**RESPONSE TO REQUEST FOR ADDITIONAL INFORMATION – DA2024/1079  
PROPERTY AT 55, 53A AND 53B WARRIEWOOD ROAD, WARRIEWOOD**

Reference is made to DA2024/1079 which seeks consent for community title subdivision into five (5) lots and civil works at 53, 53A & 53b Warriewood Road, Warriewood (the Subject Site).

**TABLE 1 – RESPONSE TO COMMENTS**

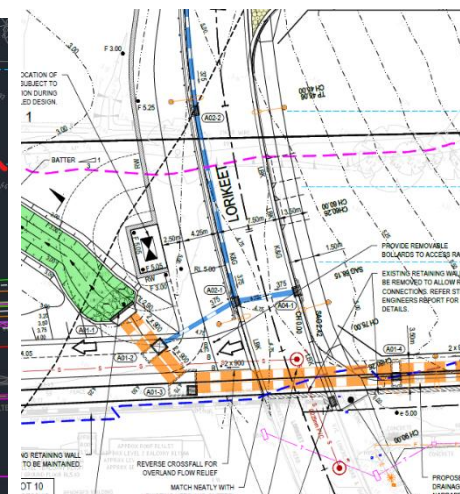
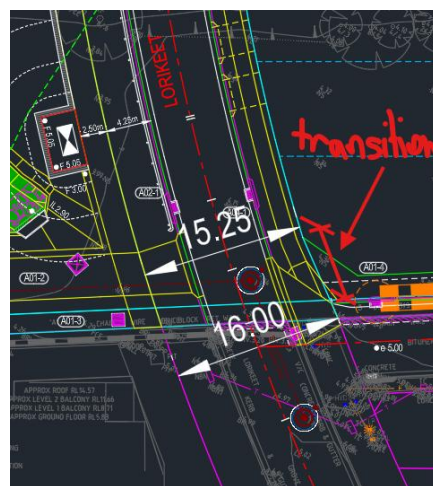
- The Lorikeet Grove road reserve is to be amended to a width of 16m to match the width approved on the adjacent site at 53C Warriewood Road.

- The road reserve currently matches 16m at the connection point to 53C Warriewood Road. It then transitions to 15.25m within the site as shown below.

Lorikeet Grove Road reserve then needs to transition to 12.5m to match with the northern portion as shown below. The 16m cannot be maintained at both connection points and therefore requires transitions throughout. We request concurrence on the current plans as provided in Civil Drawings attached at **Attachment 4**.

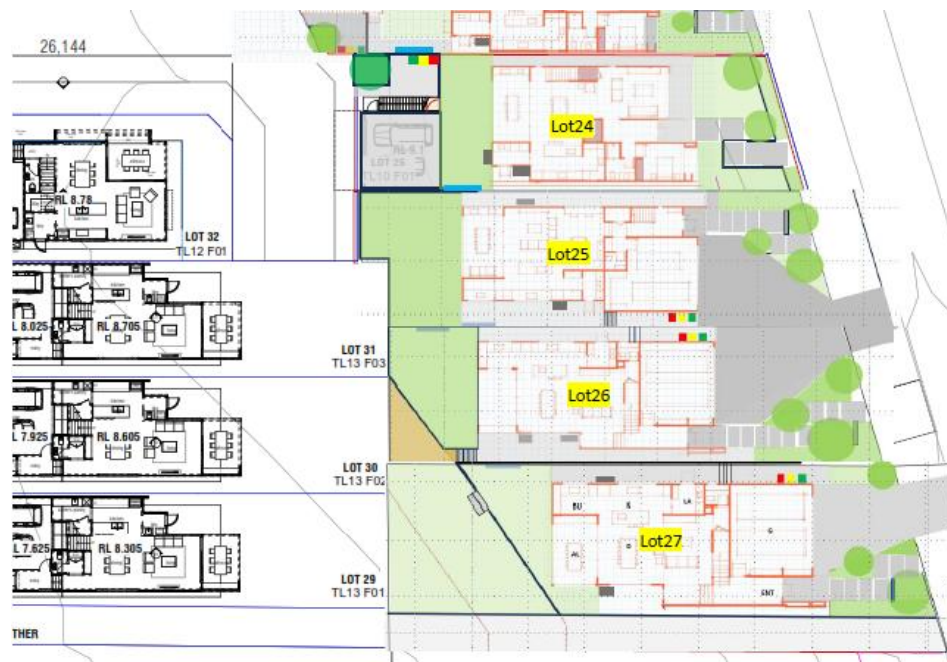
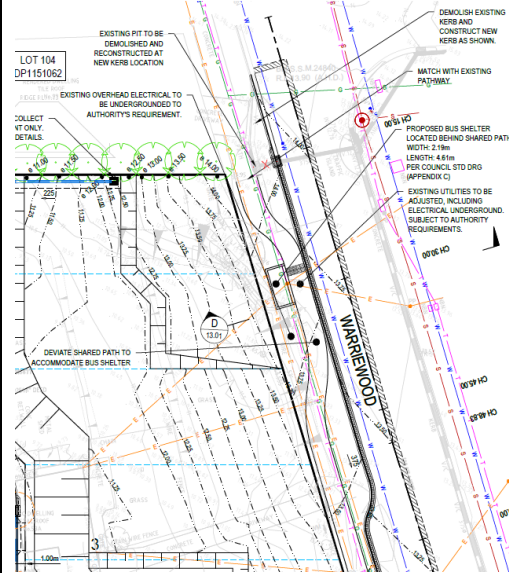
The indented bus bay on Warriewood Road now includes details for signposting of the bus stop and Bus Zone. It is also noted that the required 2.1m shared path is now shown on the western side of Warriewood Road along the frontage of the subdivision. These details are supported however, as outlined in the previous referral comments it is proposed

that a Bus Shelter will be sited at the head of the bus stop however the design details for the bus indent do not appear to allow sufficient width to accommodate a bus shelter.

Although it is not required that the developer install the bus shelter a hard stand area upon which a bus shelter can stand that is located clear of the shared path is required. This detail must be shown on the DA plans. A separate Roads Act approval will then be required for subsequent lodgement and this would be conditioned.

Due to spatial constraints, both a bus shelter, shared path, and indented bus bay cannot co-exist. We therefore propose the following option as consulted by council with their desired feedback.

Remove the indentation for the bus bay and provide bus shelter. See outcome as shown below. The shared path remains as currently documented. Profile of the shelter to be in accordance with Appendix C of WVRM.
